**DEPARTMENT OF THE INTERIOR****Bureau of Land Management****43 CFR Parts 3160 and 3170**

**Onshore Oil and Gas Operations;  
Federal and Indian Oil and Gas Leases;  
Measurement of Gas****AGENCY:** Bureau of Land Management, Interior.**ACTION:** Final rule.

**SUMMARY:** This final rule updates and replaces Onshore Oil and Gas Order No. 5 (Order 5) with a new regulation codified in the Code of Federal Regulations (CFR). Like Order 5, this rule establishes minimum standards for accurate measurement and proper reporting of all gas removed or sold from Federal and Indian (except the Osage Tribe) leases, units, unit participating areas (PAs), and areas subject to communitization agreements (CAs). It provides a system for production accountability by operators, lessees, purchasers, and transporters. This rule establishes overall gas measurement performance standards and includes, among other things, requirements for the hardware and software related to gas metering equipment and reporting and recordkeeping. This rule also identifies certain specific acts of noncompliance that may result in an immediate assessment and provides a process for the Bureau of Land Management (BLM) to consid

Figure 2

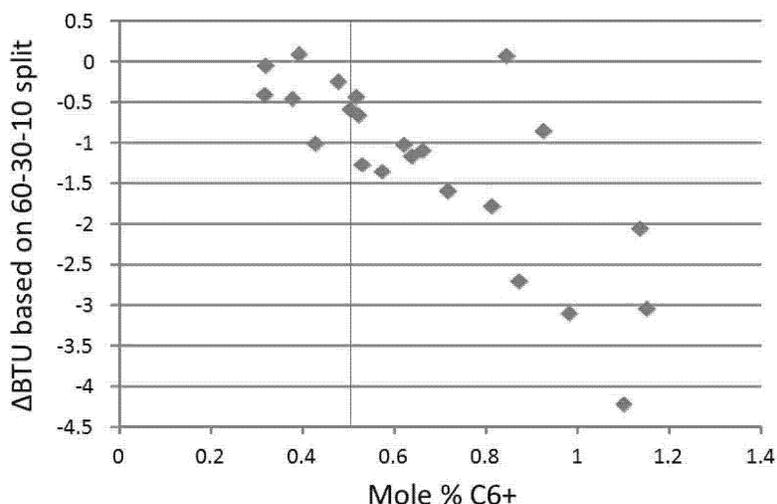
One commenter indicated that the difference in heating value between a C<sub>6+</sub> analysis and an extended analysis is less than the accuracy of the GC, and therefore, is not significant. Several commenters submitted data showing the difference in heating value based on a C<sub>6+</sub> analysis and an extended analysis. The BLM analyzed these data and generated a graph showing the difference in heating value between a C<sub>6+</sub> analysis and an extended analysis as a function of the mole percentage of C<sub>6+</sub>, assuming a 60–30–10 split of hexane, heptane, and octane, respectively (Figure 2).

points. From Figure 2, there are three points that fall outside of the  $\pm 2.8$  Btu/scf threshold at the bottom right-hand part of the graph. These three points include three of the four highest mole percentages of C<sub>6+</sub> included in the data (1.0, 1.1, and 1.15 mole percent C<sub>6+</sub>). As a result, the BLM concludes that the data presented by the commenters indicates a statistically significant bias associated with the assumed 60–30–10 split of C<sub>6+</sub> when the mole percent of C<sub>6+</sub> is 1.0 mole percent or higher. Therefore, the BLM disagrees with the comment that the difference in heating value between a C<sub>6+</sub> analysis and an extended analysis is less than the accuracy of the GC, and therefore it is not significant. The BLM did not make any changes to the rule based on these comments.

The BLM does not believe that Figure 2, generated from the data supplied by the commenters, supports the commenter’s conclusions that the difference between an extended analysis and a C<sub>6+</sub> analysis is less than the accuracy of a GC and is not significant or necessary. To analyze these data, the BLM first determined whether the apparent bias in the data as the mole

Commenters also made various suggestions regarding extended analysis that included not requiring an extended analysis in any circumstance and adjusting the C<sub>6+</sub> threshold for requiring an extended analysis to a higher percentage (suggested values ranged from 0.5 mole percent to 1.0 mole percent). The BLM agrees with the comments suggesting a different threshold and changed the threshold at which an extended analysis is required from 0.25 mole percent in the proposed rule to 0.50 mole percent in the final rule. Not only does Figure 2 show a bias in the heating value when the mole

percent of C<sub>6+</sub> exceeds 1.0 mole percent (assuming a C<sub>6+</sub> split of 60–30–10 hexane, heptane, and octane, respectively), Figure 2 also suggests a correlation (correlation coefficient of 0.61) between the concentration of C<sub>6+</sub> and heating value.

The BLM notes that Figure 2 is based on one data set that contains a fairly narrow range of heating values (1,086 Btu/scf to 1,181 Btu/scf) and, as such, may not be representative of potential bias or correlations that exist outside of that heating value range. Based on the threshold of significance analysis describe above, the BLM agrees that the 0.25 mole percent threshold from the proposed rule is too low and most likely would be less than the uncertainty of most GCs. However, the BLM believes that a threshold of 1 mole percent of C<sub>6+</sub> is too high because the evidence supplied by one of the commenters (Figure 2) demonstrates that statistically significant bias is already present when the mole percent of C<sub>6+</sub> reaches 1 percent. As a result, the BLM raised the threshold to 0.5 mole percent of C<sub>6+</sub>, which is one of the thresholds suggested by a commenter. The BLM believes that the 0.5 mole-percent threshold is a reasonable balance between ensuring that heating values are not biased and reducing the economic burden to operators associated with the 0.25 mole percent threshold in the proposed rule.

Figure 3

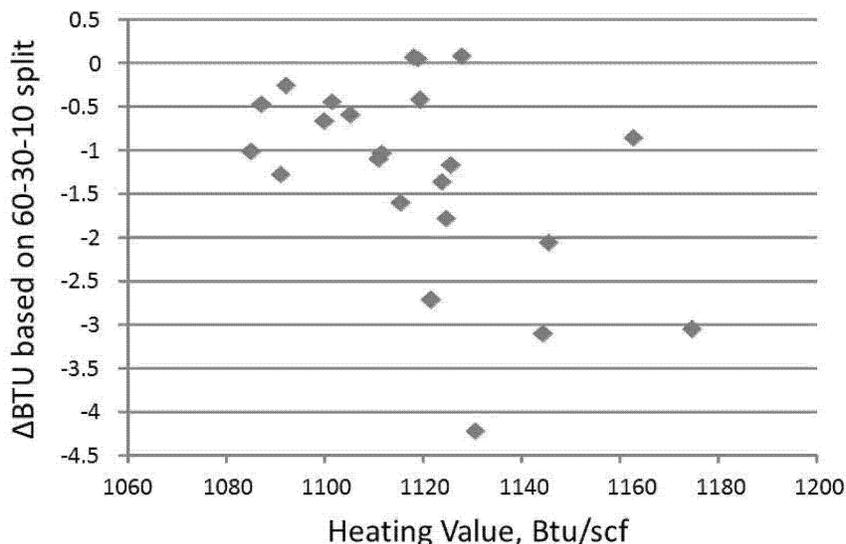
One commenter suggested basing the threshold on the Btu content in combination with the mole percentage of C<sub>6+</sub>. The BLM analyzed the suggestion of basing the threshold on the Btu content rather than on the mole percentage of C<sub>6+</sub>. Figure 3 shows the same data as in Figure 2, but plotted against heating value instead of the mole percentage of C<sub>6+</sub>. Based on an analysis of Figure 3, the BLM believes the relationship between heating value difference and heating value (correlation coefficient of 0.24) is much less clear than the relationship between heating value difference and concentration of C<sub>6+</sub>; therefore, the BLM did not adopt the suggestion to base the threshold on heating value.
